Comparison of ECE R17-08 (including amendment adopted at the 146th WP29(Nov., 08) and ECE R17-09(GRSP/2009/7 with correction proposed by GRSP-45-06).

R17-08 (including amendment adopted at the 146th WP29(Nov., 08)		R17-09 (GRSP/2009/7 and Informal Document GRSP-45-XX)		Description of Revision (Relevant proposal)
Paragraph	Text Paragraphs moved from other part are in Blue	Paragraph	Text	
			Table of contents, list of annexes, amend to read:	
CONTENTS	REGULATION	CONTENTS	REGULATION	Not changed

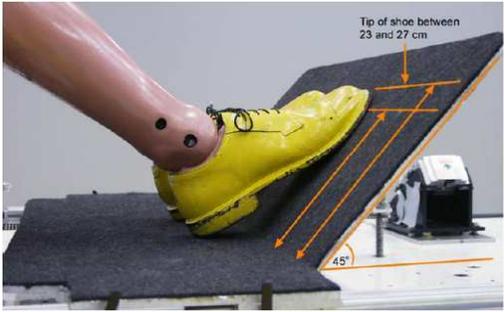
2.1.	Seat set-up	
			Adjust the adjustable head restraint so that its top is at any of the following height positions at any backset position:
